January 17, 2019

RE: Response to Crawford & Associates Comments on 850 Route 28, LLC, T/o Kingston; Ulster County; CM Project 118-207

Creighton Manning Engineering, LLP (CM) has reviewed the comments provided by Crawford & Associates Engineering, dated December 11, 2018 regarding the proposed 850 Route 28, LLC project in the Town of Kingston. Below is a summary of the *Traffic Report* comments and our responses.

Chart 1 - Expected vs Analyzed Traffic Volumes
 Building #1 and #2 Operational

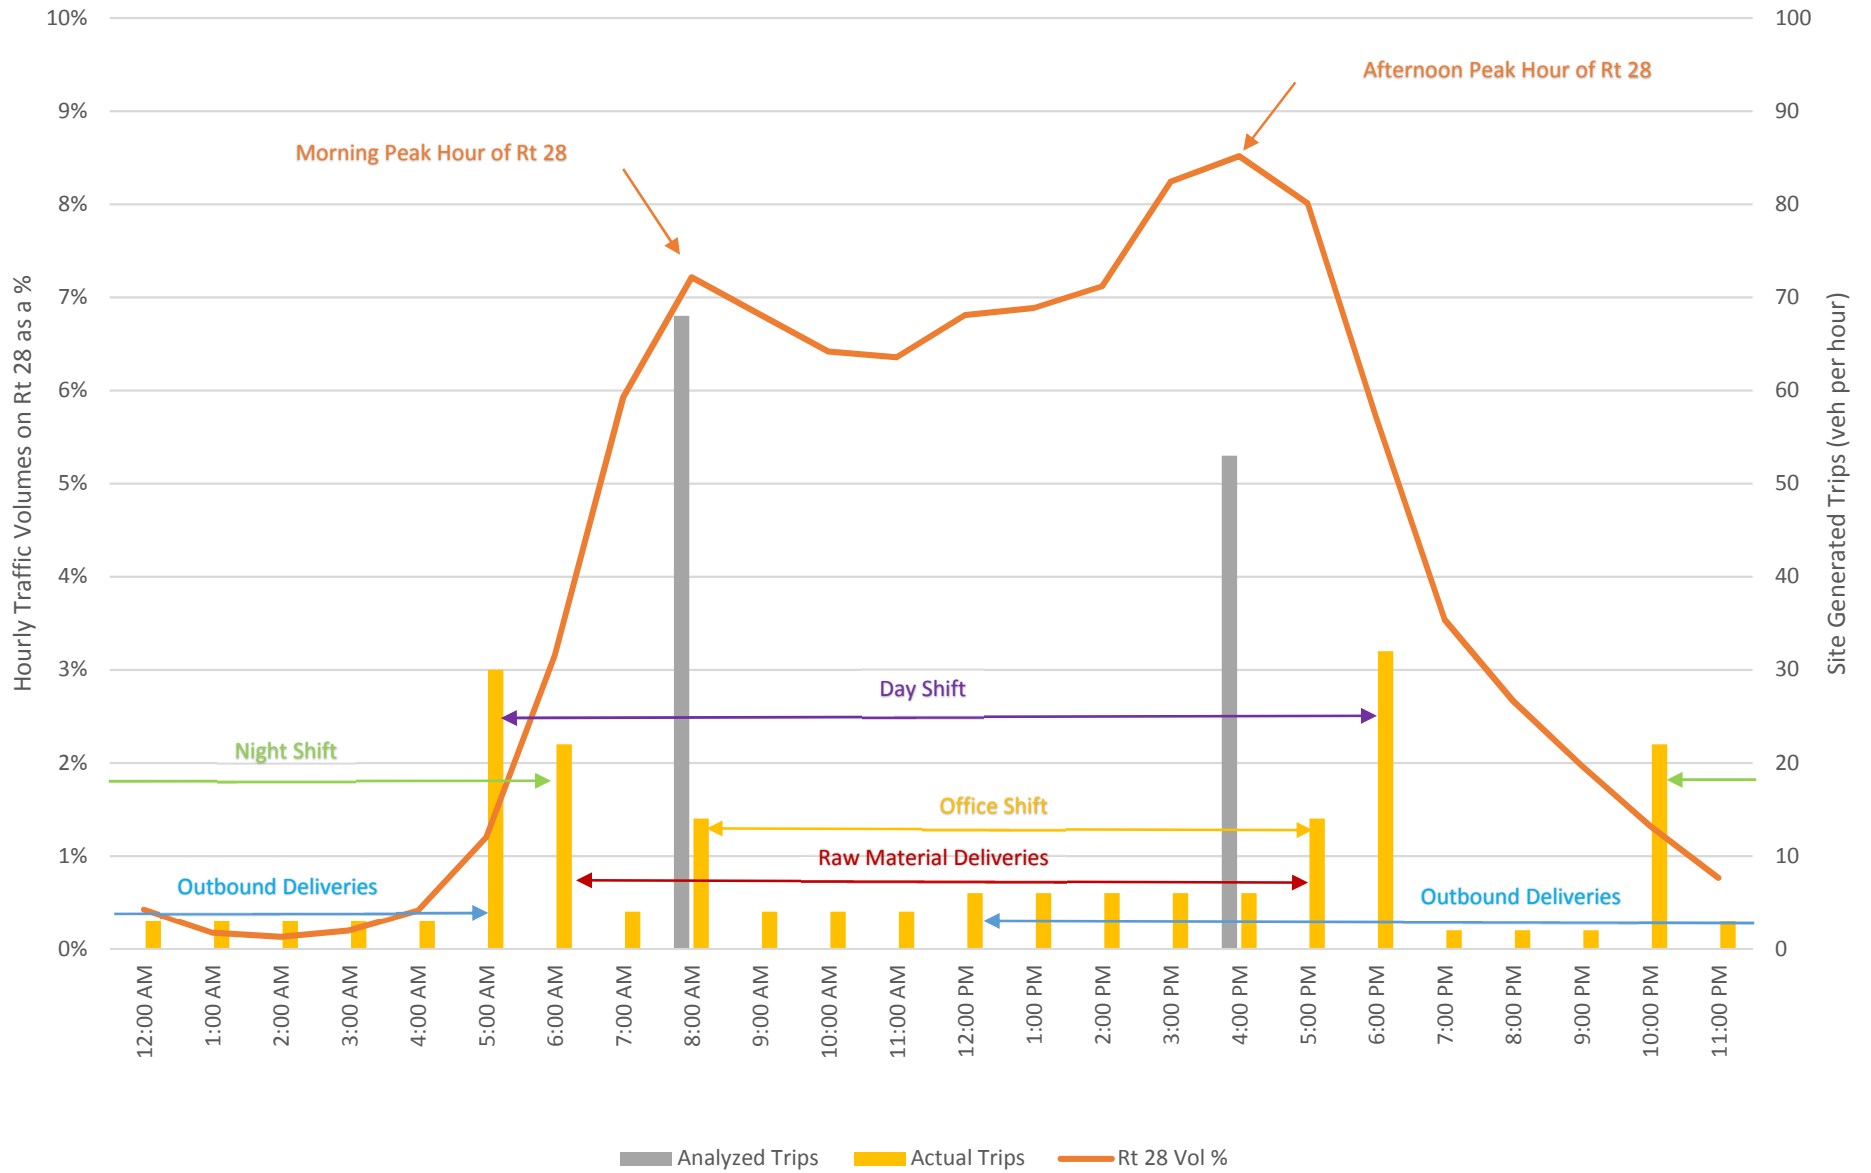
Comment #1: "Page 3 of 7 of the Creighton Manning Traffic Assessment, provides a Peak Hour Trip Generation chart to summarize the traffic volumes entering and exiting the site at the AM and PM peak hour. It is understood that Phase 1 will be completed and that the facility will begin to operate while the Phase 2 site work commences. However, page 6 of 7 provides estimated truckloads of blasted/excavated material to be approximately 16 to 20 trips per hour. The applicant should provide some clarification on the expected impact to traffic flows when Phase 2 is in construction and the facility is operating."

Response: The traffic analysis made conservative assumptions and overlapped several operations with the peak hour traffic volumes on Route 28. These assumptions provide a worst-case analysis that more than accounts for the completion of Building 1 and the construction activity of Building 2. The two attached charts have been prepared to illustrate the analysis completed and compare it to the actual expected operations at full buildout and at the completion of Building 1, with Building 2 under construction.

Chart 1 illustrates the distribution of traffic volumes on Route 28 over the course of an average day as a percentage of the daily volume. For example, the morning peak hour volume on Route 28 is about 7% of the daily volume and occurs between 8 and 9 a.m., while the afternoon peak hour is about 8.5% and occurs between 4 and 5 p.m. The shape of this line distinctly show volumes increase in the morning and decrease in the evening with morning and afternoon peaks. The analyzed trip generation (68 AM trips, 53 PM trips) assumed several activities coincide with the morning and afternoon traffic volumes peaks to represent a worst-case analysis. Chart 1 also illustrates the actual expected trip generation for the site with both buildings operational. The day shift arrives before the night shift departs, both occurring before the peak of Route 28, when traffic volumes are less than half of the morning peak. The office workers arrive during the morning peak, but depart at or slightly later than the afternoon peak. Day shift and night shift depart/arrive, well after the afternoon peak on Route 28 when traffic volumes are about 40 to 90% less. Daytime trips (7 a.m. to 6 p.m.) average about 7 trips per hour.
